Our reference: ECM: 9783432 Contact: Kathryn Saunders Telephone: (02) 4732 8567

Request for Advice – Request for Further Information for Oakdale West Estate Stage 3 - SSD-9794683 at 2 Aldington Road Kemps Creek

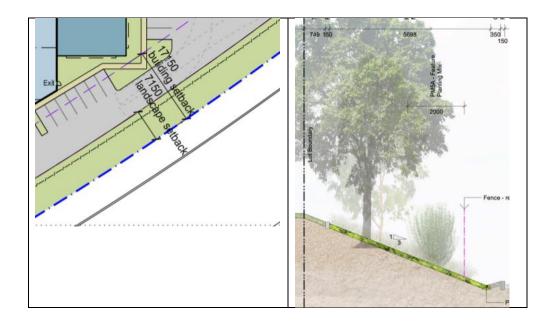
Should the Department support the reduction in landscaping along the frontage of the site to Southern Link Road, Council strongly recommends that larger scale landscape blisters be introduced to the car parking proposed along this frontage at a minimum of 1 in each 6 spaces, the loss of car parking spaces is considered acceptable (and is encouraged) to facilitate this outcome.

This is considered to be essential to ameliorate the increased impacts of bulk, scale and overbearing owing to the reduced landscaped setback, and to screen the view to hard stand loading and service areas.
